HISTORIC AND DESIGN REVIEW COMMISSION

April 20, 2022

HDRC CASE NO: 2022-221
ADDRESS: 329 CLUB DR
LEGAL DESCRIPTION: NCB 6704 BLK 14 LOT W 32 FT OF 7 & E 25 FT OF 8
ZONING: R-6 H
CITY COUNCIL DIST.: 7
HIST. DIST. NAME: Monticello Park
APPLICANT: Mike Garcia
OWNER: Manuel Garcia/CENTEX REI LLC
TYPE OF WORK: Exterior alterations, repair and maintenance, window replacement
APPLICATION RECEIVED: March 22, 2022
60-DAY REVIEW: Not applicable due to City Council Emergency Orders
CASE MANAGER: Jessica Anderson

EXTERIOR FRONT ELEVATION

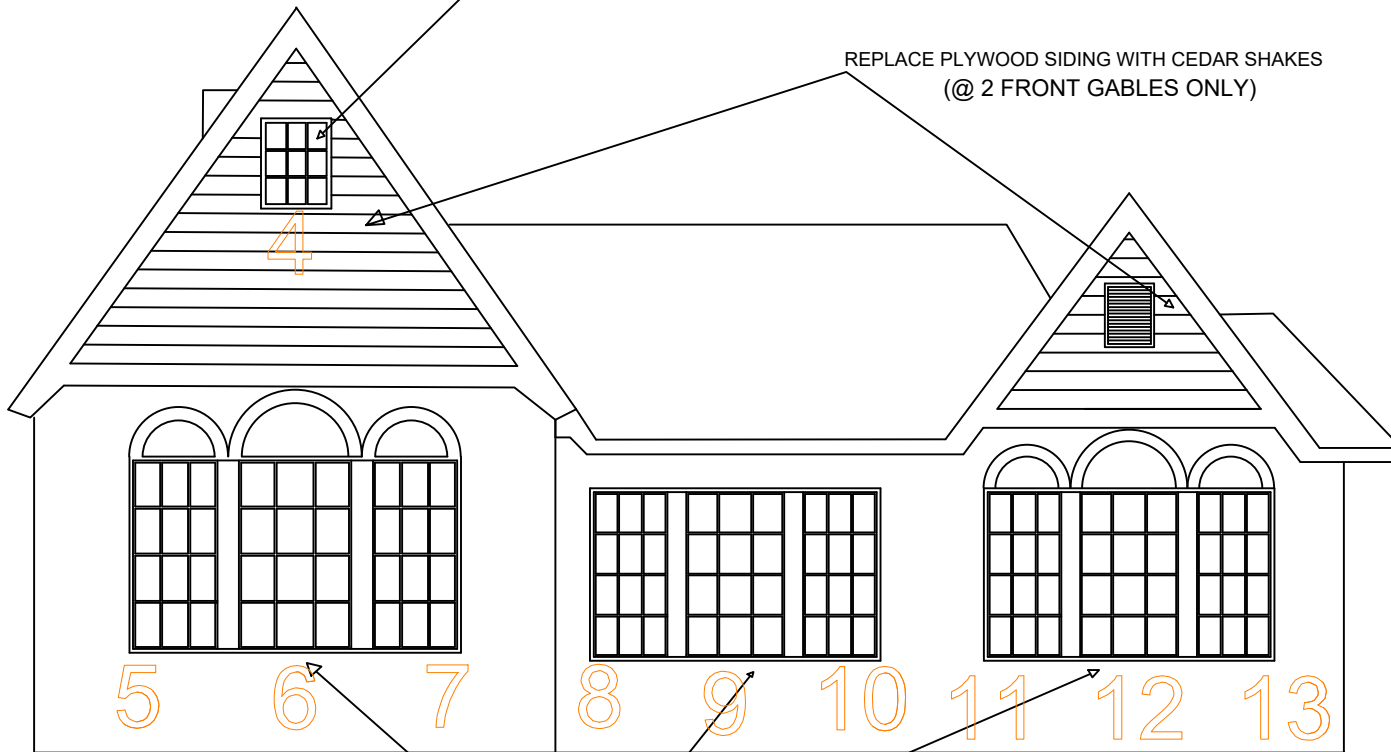
- f. **WINDOW REPLACEMENT:** The applicant reports replacing existing aluminum windows on the second floor due to concerns about their condition as well as to meet egress requirements per a building inspector. Four windows were replaced with Ply Gem 300 Series aluminum single-hung windows in bronze measuring 35.25"x47.25". Photos of the east elevation submitted by the applicant as part of another request in September 2021 show a square metal-sash window; staff was unable to determine exact dimensions of the previous window. The replacement window is rectangular. Photos of the west elevation submitted by the applicant in September 2021 do not clearly show the second-story window; they are obscured by trees. Replacement of aluminum windows in-kind may be appropriate provided that the windows adhere to staff's standards for replacement windows. The windows that have been installed do not meet staff's standards for replacement windows, as they feature faux divided lites. Staff finds that windows that are consistent with staff's standards for replacement windows should be installed.

- i. **GABLE DESIGN:** Per photos submitted by the applicant in September 2021, the primary gables were clad in wood paneling to match non-primary gables. The applicant has since installed wood singles in the primary gables. Staff finds this to be inappropriate and finds that the previous condition should be returned.

- ii. That the metal railings are reinstalled or replicated.
2. Staff does not recommend approval of item #2, window replacement, as installed. Staff recommends the applicant install windows consistent with staff's standards for replacement windows. Window product specifications should be submitted to OHP staff for review and approval.

5. Staff does not recommend approval of item #5, gable design modification. Staff recommends returning the gables on the primary elevation to their previous condition.
6. Staff does not recommend approval of item #6, modification of front walkway based on finding j. Staff recommends the front walkway be returned to its previous condition.
7. Staff recommends approval of item #8, modifications to the accessory structure, with the following stipulation:
 - i. That the applicant submit more detailed drawings of proposed changes to the accessory structure prior to the issuance of a COA.

Proposed walkway treatment

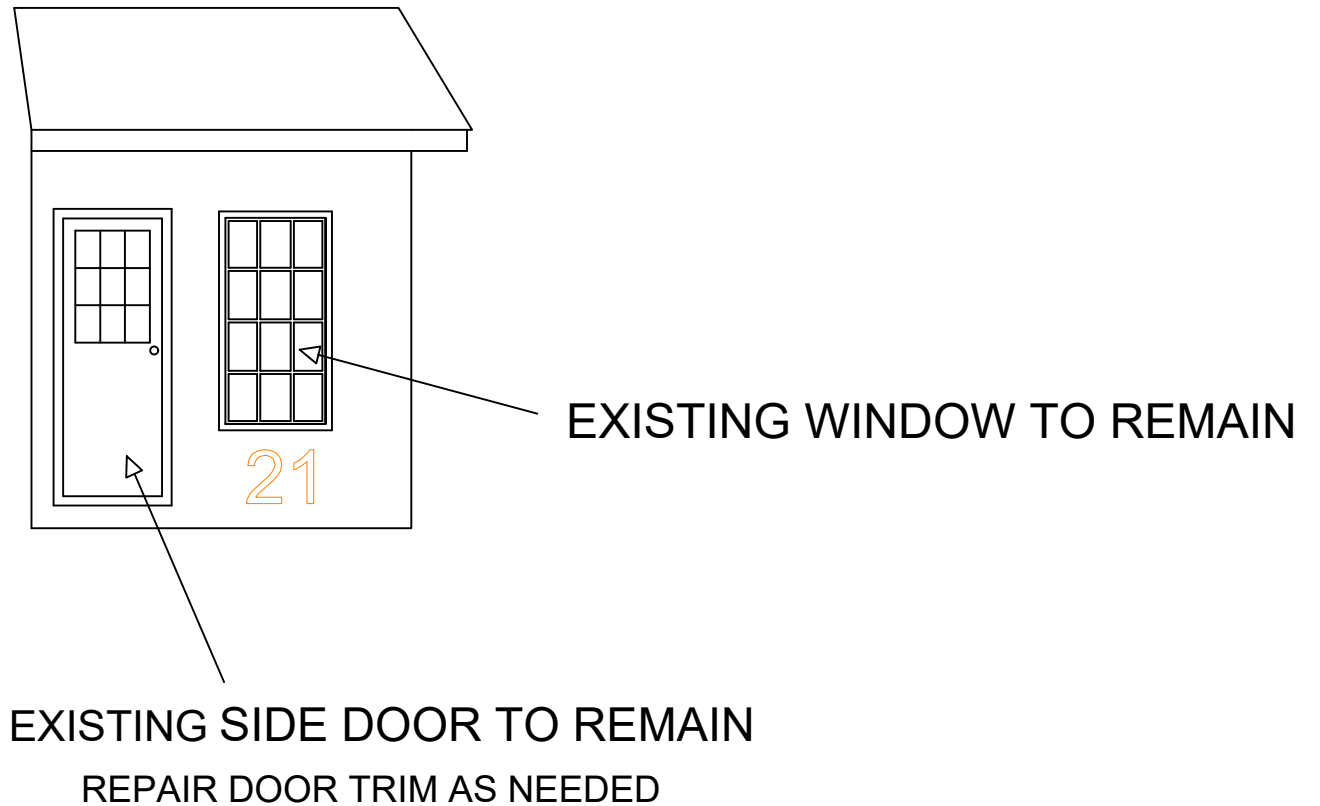
- j. **FRONT WALKWAY DESIGN:** The applicant removed short sections of the existing concrete walkway from a staircase to the front porch so that the sidewalk appears as large concrete pavers. The applicant proposes a design for the front walkway that incorporates brick borders separating each concrete paver and along both sides of the path. The Guidelines for Site Elements note that existing concrete walkways should be repaired in-kind. Staff finds the proposed modifications to be inappropriate.

ROCK STRUCTURE WOODEN GABLE PATIO COVER PLANS

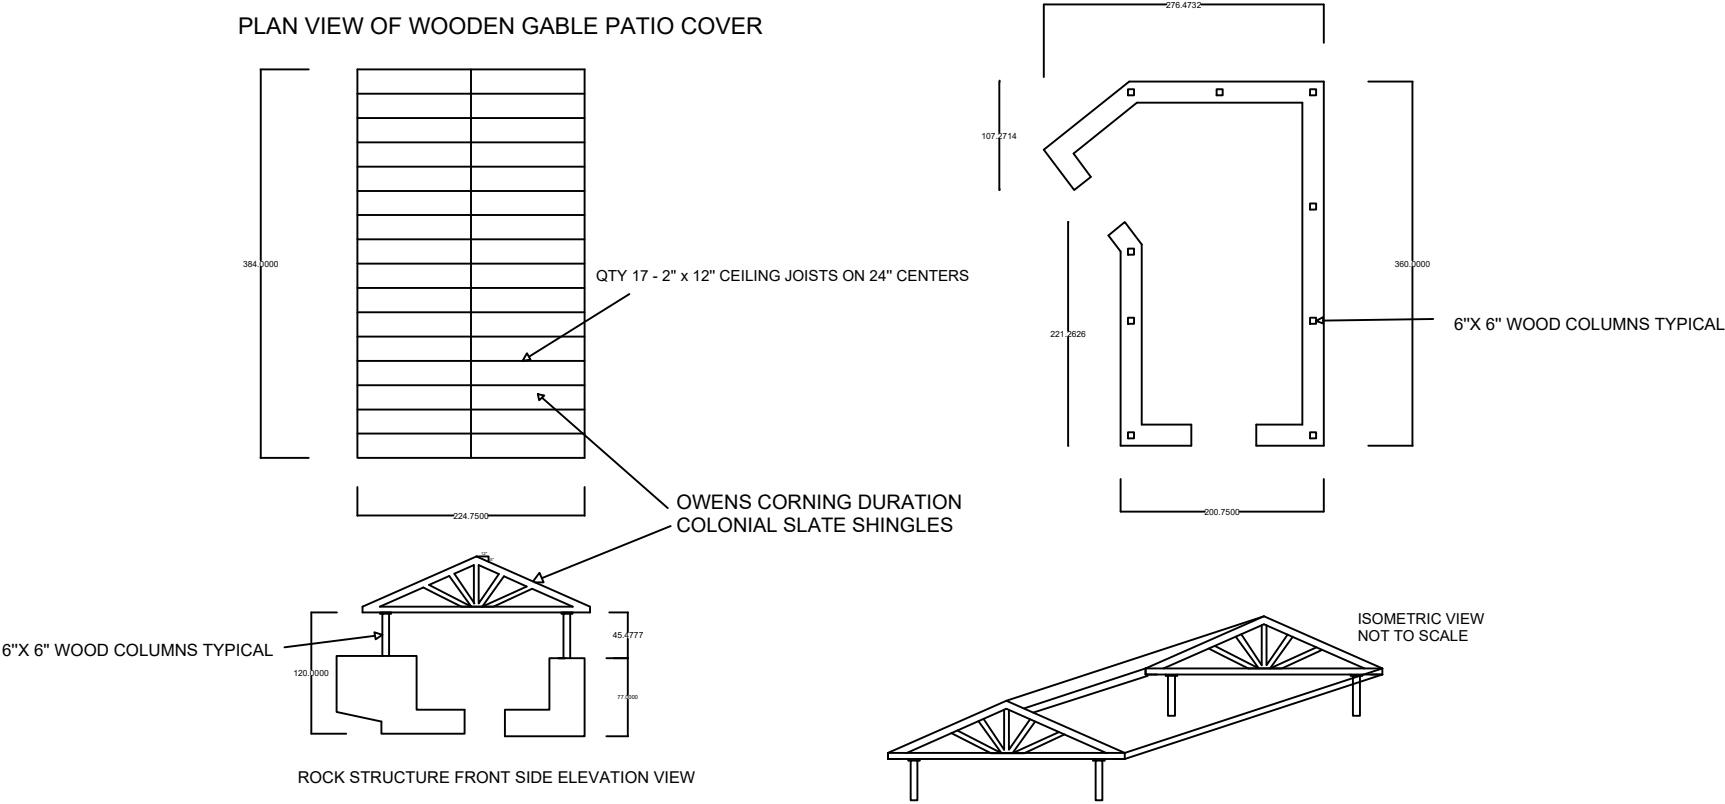
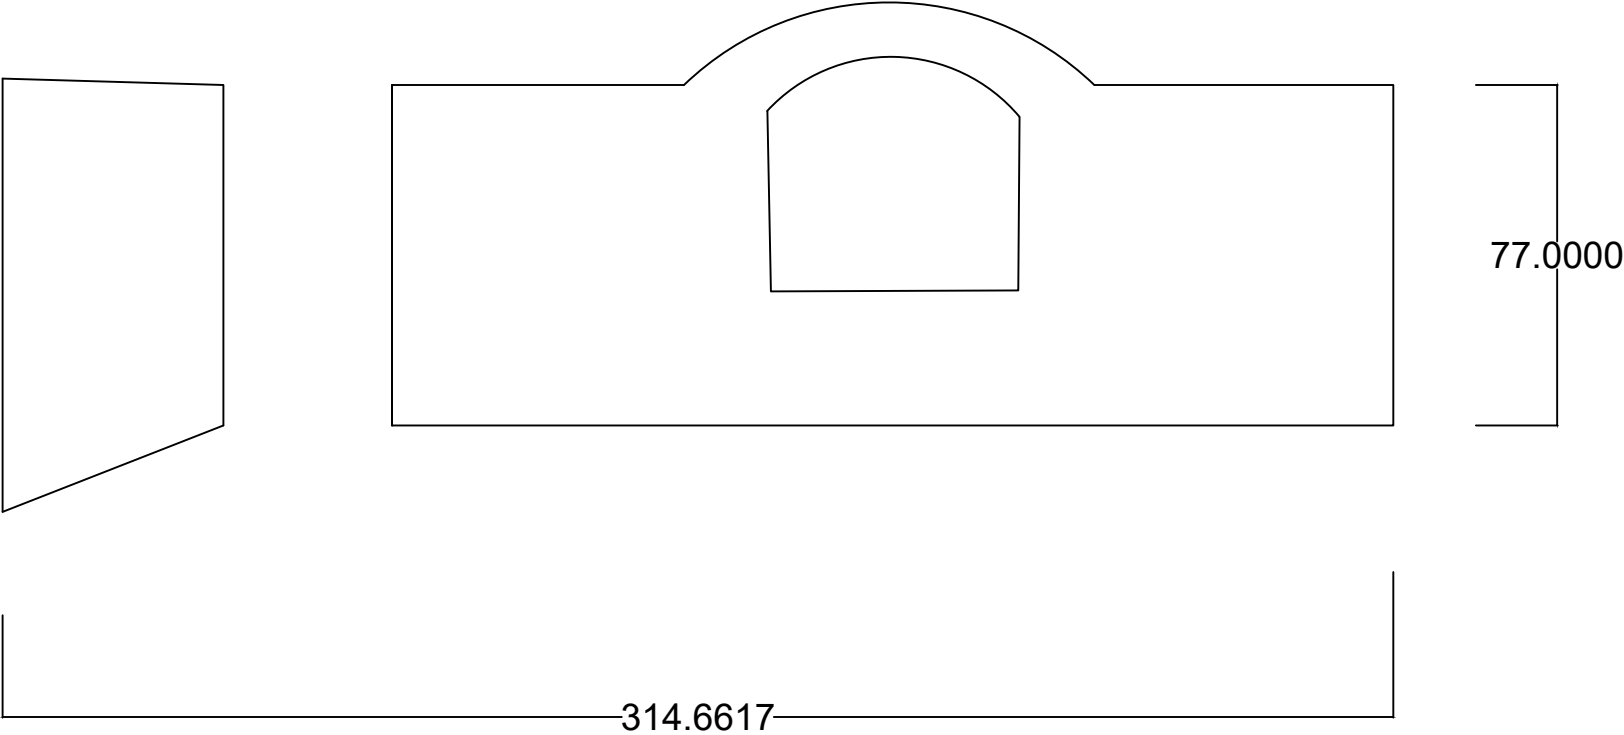
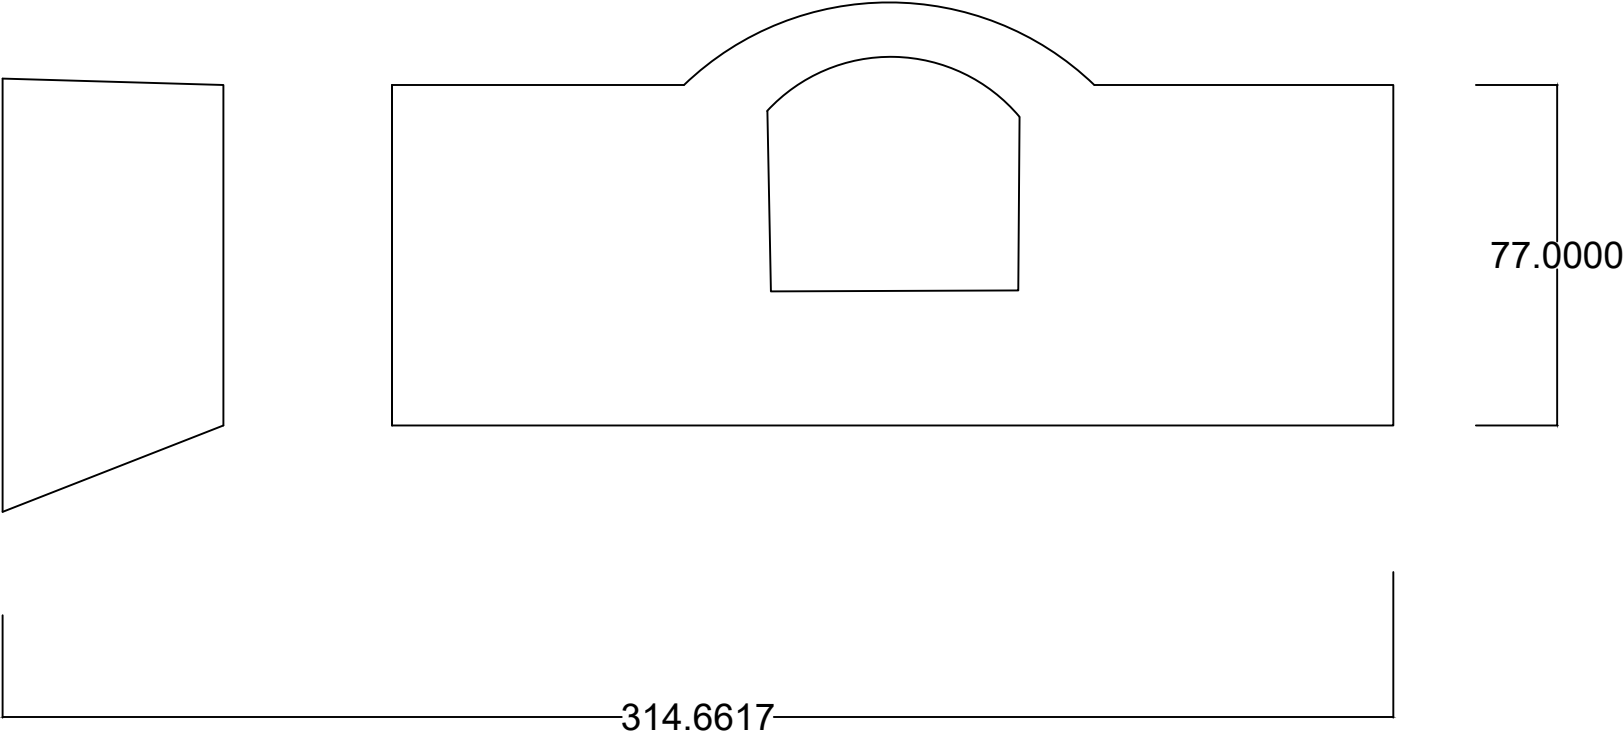
- l. **ACCESORY STRUCTURE:** The applicant proposes to add an approximately 600 square foot (18.75'x32') end-gabled roof with composition shingles on 6"x6" wood posts to the top of the existing stone structure in the rear. Generally, staff finds this scope of work to be appropriate; however, the applicant should submit more detailed drawings prior to the issuance of a COA.
